CONDITIONS OF APPROVAL:

Engineering - Development Plan Checklist

**57. Offsite Drainage**

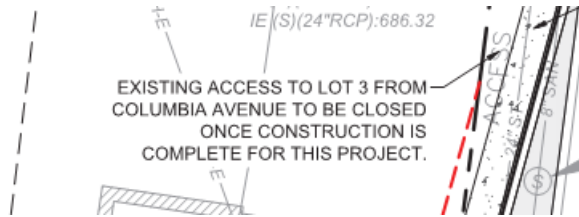
[lance.fittro@franklintn.gov](mailto:lance.fittro@franklintn.gov) New construction shall not aggravate upstream or downstream flooding. Where existing upstream or downstream stormwater problems exist, Applicant shall correct existing problems in conjunction with new development or redevelopment. *[COF Stormwater Ordinance Sec. 23-106 (2) (i) (iii)]*

Existing offsite downstream stormwater infrastructure may have insufficient capacity to transfer flows from the site. The extents of the insufficient infrastructure is currently unknown. **With the first Site Plan**, Applicant shall analyze existing downstream stormwater infrastructure and correct deficient areas.
